# Sheringham Shoal and Dudgeon Offshore Wind Farm Extension Projects

## Marine Processes Technical Note

**Revision A** February 2023 Document Reference: 13.5

Title:				
Sheringham Shoal and Dudgeon Offshore Wind Farm Extension Projects Examination submission Marine Processes Technical Note				
PINS document no.: 13.5				
Document no.: C282-RH-Z-GA-00229				
Date:	Classification			
20/02/2023	Final			
Prepared by:				
Royal HaskoningDHV				
Approved by:		Date:		
Tom Morris, Equinor		20/02/2023

Figure 1 Bathymetry of the sandwaves across Cromer Knoll Bank at the northwest of the DEP North array area and at the northern end of the interlink cable corridor between the DEP North array area and SEP

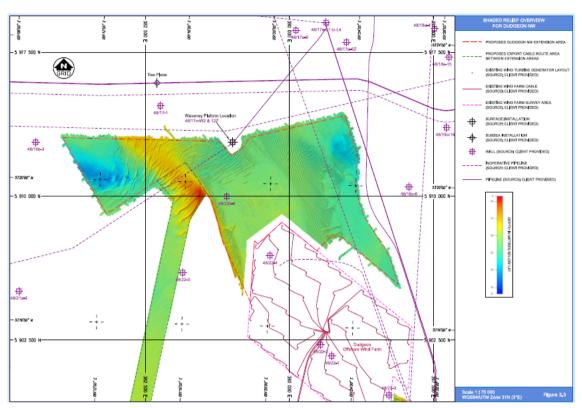
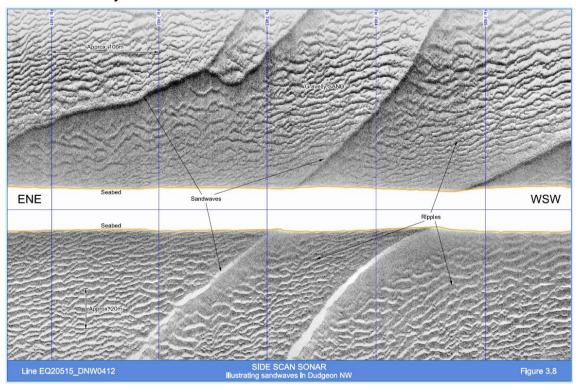
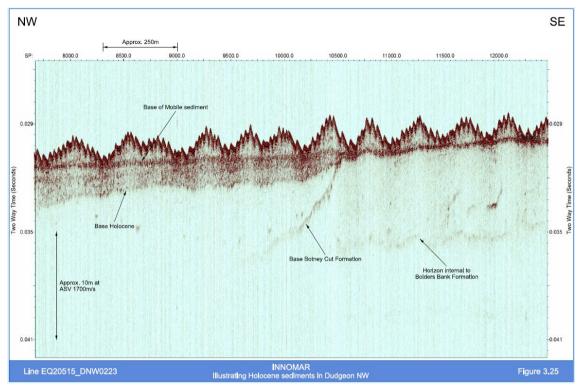
- 6. ID 21: The text describes a sandbank in [northwest] NW of DEP N array area and also a sandbank in the NW of DEP S array area. The bathymetry shows the presence of significant sandbanks, which are probably Cromer Knoll and Inner Cromer Knoll, but no information has been provided regarding their form, spatial extent, elevation, depth, rate of migration and stability. We would advise that in order

to understand impacts of the development on these sandbank features, it is important to first characterise their form, extent, elevation, rate of migration and stability. Please can the Applicant provide this information in an updated chapter.

- 9. About 5km (running northwest to southeast) of the Cromer Knoll Bank crosses the northwest of the DEP North array area, with a further 3km at the northern end of the interlink cable corridor between the DEP North array area and SEP, and 3km at the northern end of the interlink cable corridor between the DEP North array areas (Figure 6.1 and Figure 6.3 of the ES [APP-119]). All three parts of the bank recorded in these areas are covered in sandwaves with crests oriented northeast to southwest (approximately). Gradients of greater than 10° are observed on the flanks of the sandwaves (Gardline, 2020).

- 10. The crest of the bank inside the northwest part of the DEP North array area and at the northern end of the interlink cable corridor between the DEP North array area and SEP has a shallowest depth of 13m below Lowest Astronomical Tide (LAT) and is up to 9m above the surrounding seabed (Gardline, 2020). Sandwaves up to 4-5m high with wavelengths of around 250m are prevalent across the bank. The bathymetry across these sandwaves is shown in Figure 1, a side-scan sonar example in Figure 2 and a sub-bottom profiler example in Figure 3.

*Figure 6 Bathymetry of the eastern tip of Sheringham Shoal Bank inside the export cable corridor*

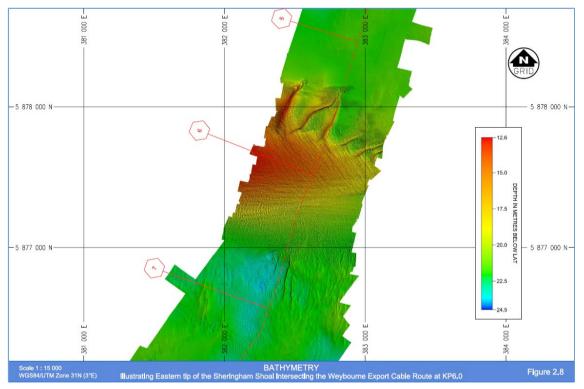
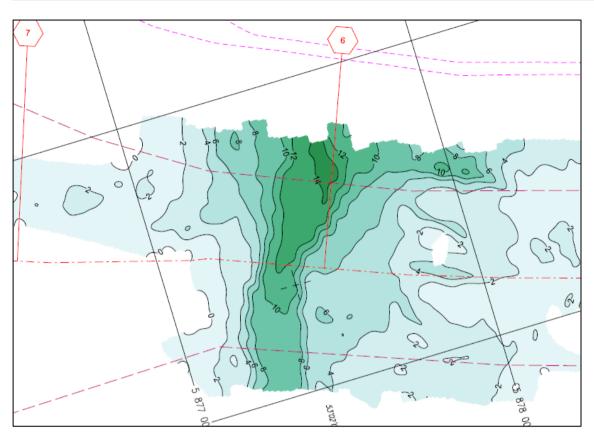
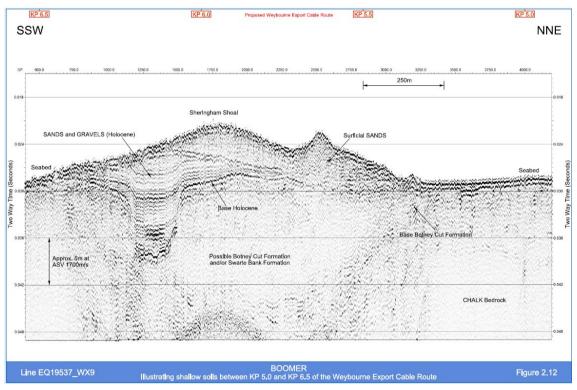
7. ID 28: Natural England notes that the 'Sand banks (and associated sandwaves)' Receptor Group does not include any mention of Sheringham Shoal, Pollard Bank, Cromer Knoll, Inner Cromer Knoll, sandwaves in SEP, sandbanks situated at the NW of DEP N array and in DEP S, and in the north of the cable corridor between DEP N array and SEP. We advise that all sandbanks within the OLs for the project, should be included and named, where possible in an updated chapter.

14. The eastern tip of Sheringham Shoal Bank is inside the export cable corridor about 10km from the coast of north Norfolk. Here the bathymetry of the bank is about 16m below LAT (Gardline, 2019) (Figure 6). The crest of the bank is 8-14m thick inside the cable corridor (Figure 7 and Figure 8) but is much thicker to the west outside the cable corridor. It is covered in a field of megaripples, which are up to 0.5m high with wavelengths up to 16m, and crests typically oriented north-south or north-northeast to south-southwest (Gardline, 2019). The northern flank contains sandwaves with heights of about 3-4m, wavelengths up to 150m, and crests oriented approximately north-northeast to south-southwest (Figure 9). They are asymmetrical with their steeper sides facing east-southeast implying migration in the same direction.

Figure 9 Zone of Potential Influence on the Tidal regime and spring tidal ellipses

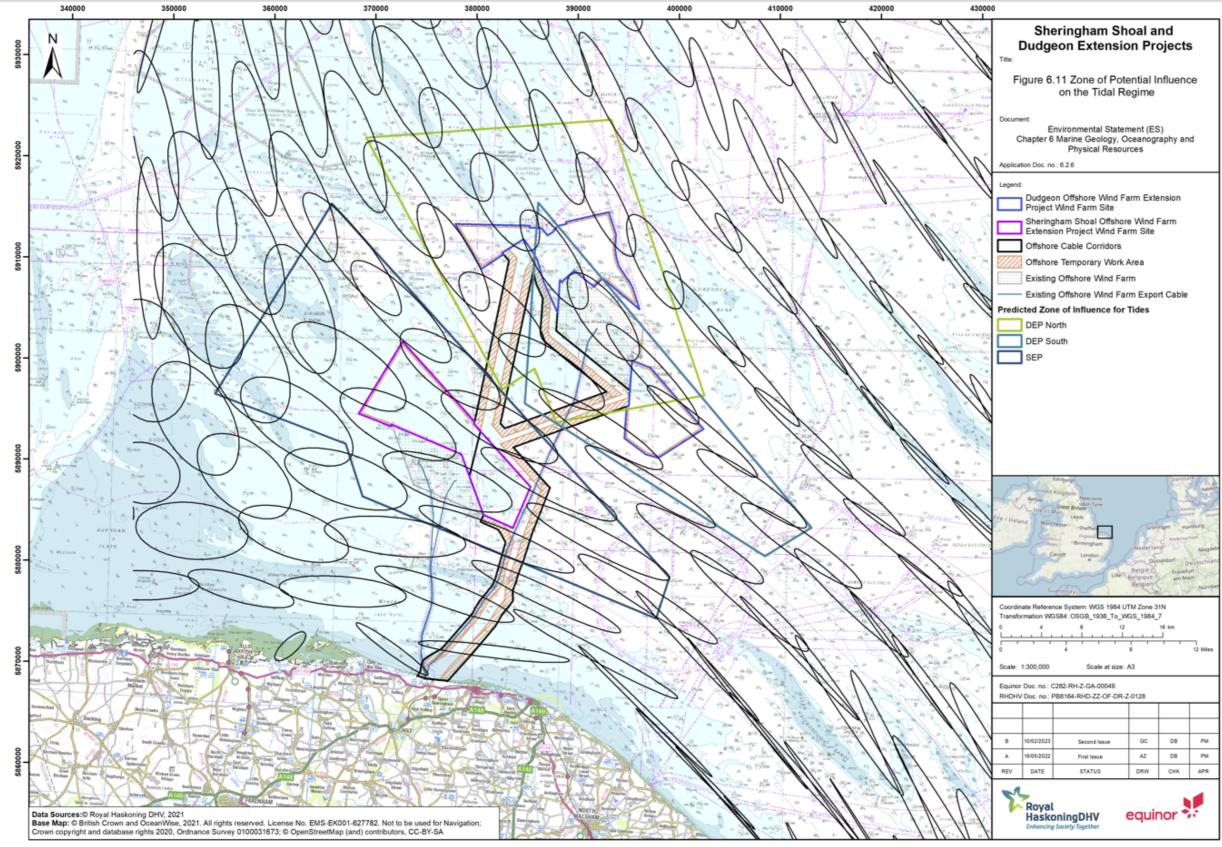
- 19. *ID 6: In addition, there does not appear to be a map showing the spring tidal ellipses across the study area.*
- 20. ID 23: Natural England notes that the neap and spring tidal excursions have not been provided. The spring tidal excursion is useful for estimating the potential extent of direct changes to flows as well as the anticipated maximum zone of influence for

sediment plumes. We advise that the Neap/spring tidal excursions should be quantified in an updated chapter. It would also be useful to provide a map showing the spring tidal ellipses across the study area.

21. The spring tidal ellipses across the study area are provided in **Figure 9** below. The ellipses provide an indication of the maximum extent to which a particle of sediment in the water column could travel. However, given the relatively coarse nature of the sediment across the array sites, the small magnitude of the plume of fine sediment would mean that most particles would not achieve this maximum extent, as they would settle to the seabed a shorter distance from their release point (up to a kilometre along the axis of tidal flow) rather than travelling to the full extent of the ellipse. However, the lowest suspended sediment concentrations would extend further from the point of release, along the axis of predominant tidal flows (long axes of the ellipses), but the magnitudes would be indistinguishable from background levels.

Figure 10 Zone of Potential Influence on the tidal regime in the context of marine protected areas

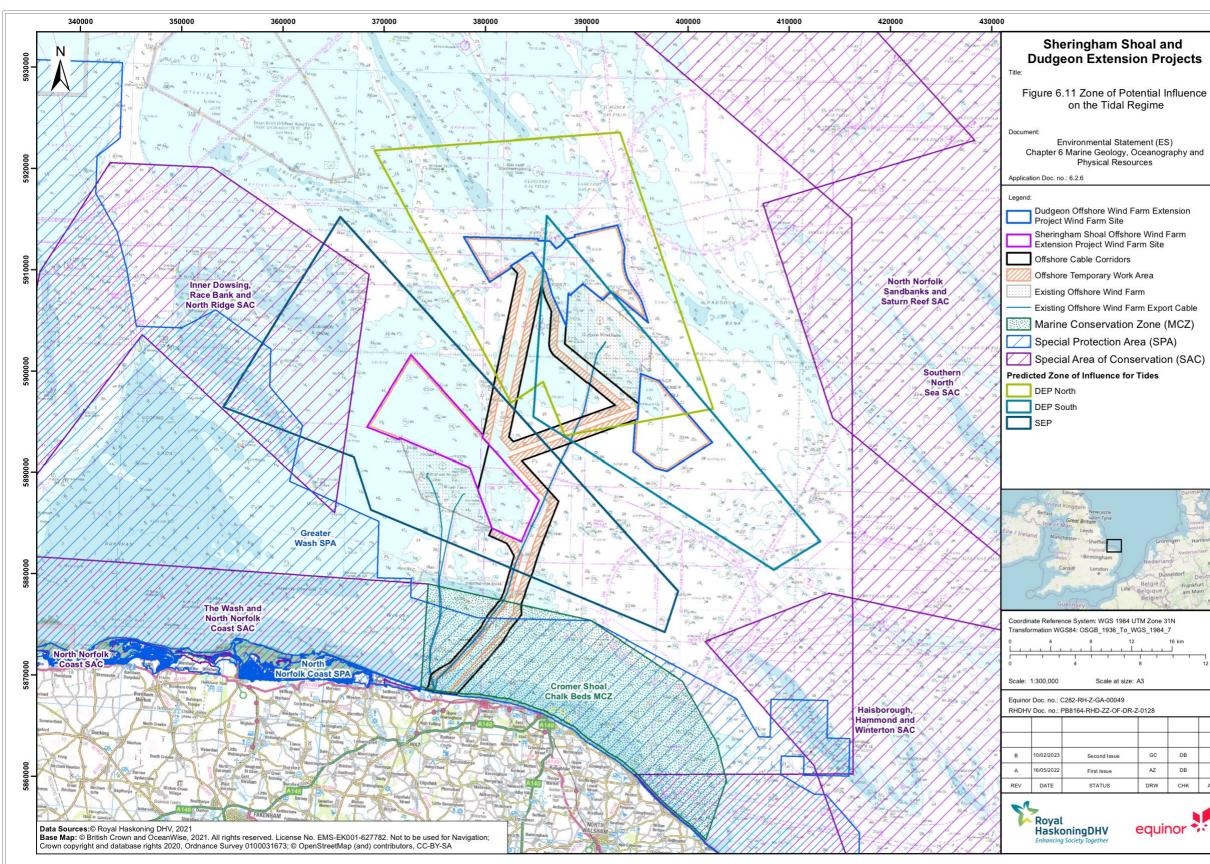
23. ID 47: Point 316. The maximum zone of potential influence (ZoPI) on the tidal regime is presented in Figure 6.11, which we welcome. However, marine protected areas have not been identified on this map. It would be useful to identify marine protected areas on Figure 6.11 to show where they overlap with the ZoPI.

24. The updated Figure 6.11 is provided as **Figure 10** below. With respect to the overlap shown with the Inner Dowsing, Race Bank and North Ridge Special Area of Conservation (SAC), the potential increased suspended sediment concentrations (SSC) and deposition effects during construction, operation and decommissioning; and changes to physical processes resulting in changes to sediment supply (i.e. sediment transport effects) during operation (but in relation to the SEP wind farm site only), are assessed within the **Report to Inform appropriate Assessment (RIAA)** [APP-059].

Figure 12 Predicted suspended sediment plume during a spring tide

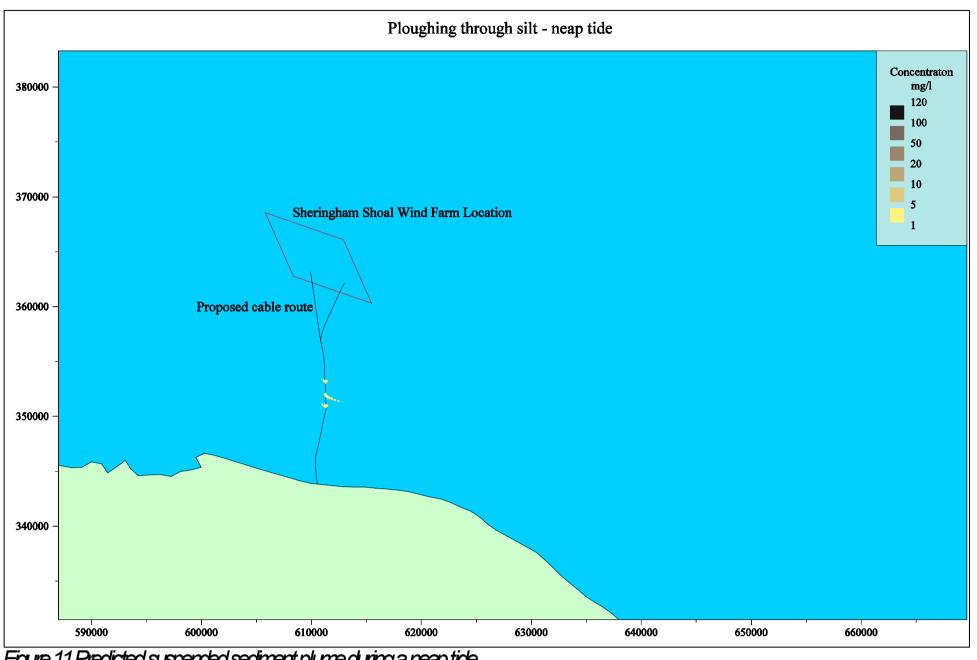
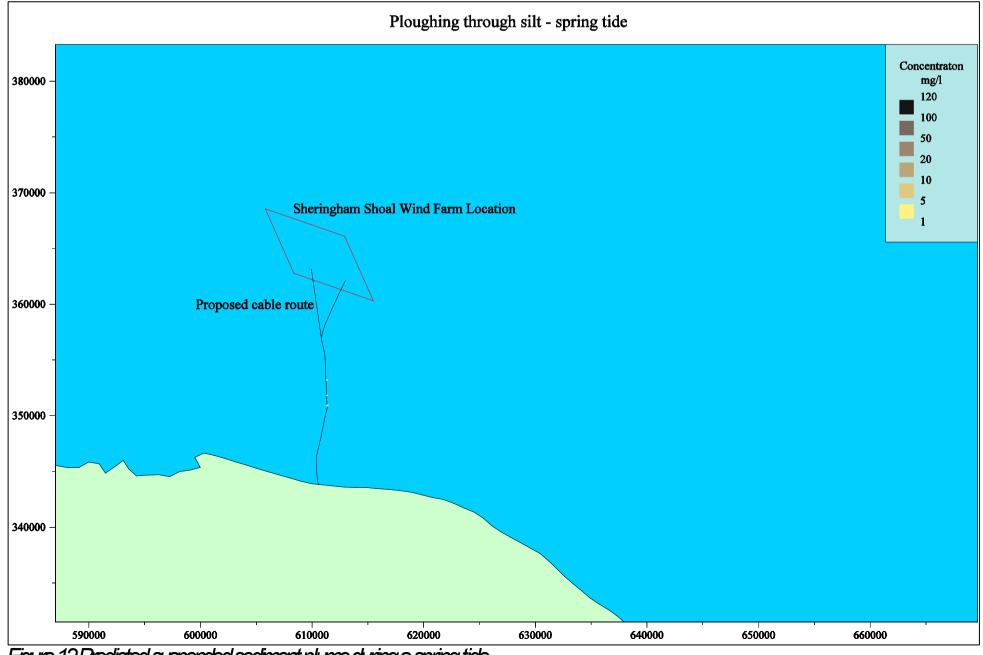
- 26. ID 37: Points 239-241. The SOW and DOW-based model simulation quantification of magnitude of change are useful analogues for the SEPDEP export cable for sediment disturbed by export cable installation. However, it is not clear if/how the SOW/DOW max temporary disturbance widths for export cable installation and burial, or amount of sediment disturbed compare with those for SEP/DEP. This should be clarified. Furthermore, in Point 239, it is stated that although SSCs will be elevated they are likely to be lower than concentrations during storm conditions (including the Dec 2013 storm surge), which are likely to drive greater changes to the seabed than those due to the OWF infrastructure. Natural England advises that within an updated chapter it should be shown how the SOW/DOW trench size and amount of disturbed sediment compare with those for SEP/DEP. Quantitative evidence should be provided to support the predictions regarding SSCs.

- 28. ID 39: Points 255 & 256. Results from the sediment dispersion modelling for the SOW and DOW export cables (Points 170 & 171 in Chapter 6), suggest that suspended load for disturbed mud would extend as a plume over <2km for SOW, and <1km for silt in either direction. However, as noted above, there is no information on the max disturbance width or amount of sediment disturbed due to cable installation at DOW/SOW, compared with those at DEP/SEP. Please provide further clarification within an updated chapter.

- 29. ID 40: Point 255. Given that the [export cable corridor] ECC traverses the [Cromer Shoal Chalk Beds] CSCB MCZ, it would be very helpful if the plume model data for SOW/DOW could also be provided as predicted deposition footprints for representative locations between the HDD exit location and seaward boundary of the MCZ. These should be representative of the different sedimentary zones along the ECC within the MCZ and also include the HDD exit location. Furthermore, it is not stated what the estimated deposited sediment thickness may be for the different sediment fractions (i.e. fine/medium/coarse) due to export cable installation. Modelled deposition footprints and thickness should be provided for locations representative of the different sedimentary zones along the ECC within the MCZ and include the HDD exit location. Can estimated deposited sediment thickness be provided for the different sediment fractions?

- 34. **Figure 11** and **Figure 12** illustrate the results of the sediment dispersion modelling for the SOW export cable based on the parameters described by Scira (2006). They describe the footprint of dispersion that represents the peak increase of suspended sediment experienced at each point in the model domain over the full duration of the simulation. The minimum contour value is a 1mg/l increase as it is assumed that any value below this is negligible in relation to the background situation.

- 35. They show that the neap tide footprint is predicted to extend less than 2km, while the spring tide footprint is very small. The neap tide footprint is larger due to the lower rate of turbulent diffusion. If the extent of the footprint and magnitude of concentrations are upscaled by 1.6 times to account for the difference in sediment disturbance volumes between SEP/DEP and SOW, then the spread would be less than 3.6km on a neap tide and remain very small on a spring tide. Suspended sediment concentrations are likely to be higher, but would only be less than 10mg/l, conservatively.

Figure 13 Difference in bathymetry between 2013 and 2018 across the DOW array area

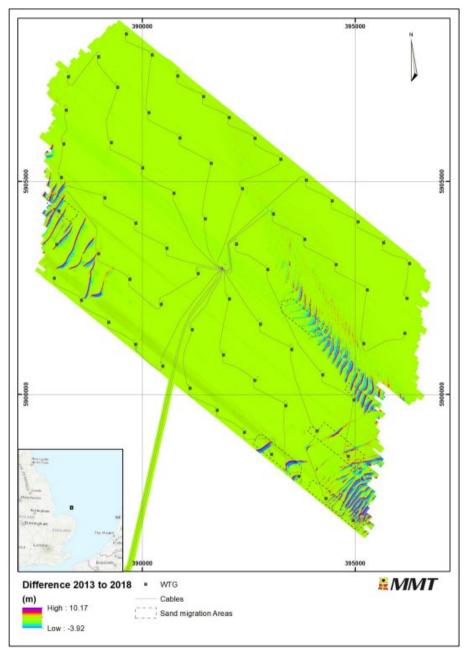
- 40. ID 6: In addition, there does not appear to be DOW geophysical survey data to support conclusions that construction-related effects were minor and localised and that the seabed topography has not changed greatly.

- 41. ID 52: Point 337. Geophysical survey data from the existing OWFs are useful. However, it is stated that the DOW geophysical survey shows that only minor and localised effects remain from the wind farm construction, and that the 'overall topography of the seabed within DOW has not greatly changed'. However, it does not state when this survey was undertaken, nor what the minor and localised effects might be that remain, nor how the seabed is not greatly changed and since when. This should be made clearer as it is too vague to provide any useful comparison with SEPDEP. Furthermore, does the post-construction survey show any evidence of change to sandbank morphology or migration rate across DOW?

44. MMT (2018) reported the results of a full site comparison between 2013 and 2018 and a sandwave migration analysis (between 2007 and 2018) across six sites within the DOW array area. **Figure 13** shows a difference plot between the 2013 and 2018 bathymetry datasets for the whole array. The data shows that, apart from the areas of mobile sandwaves, there has been little change in the overall seabed depth.
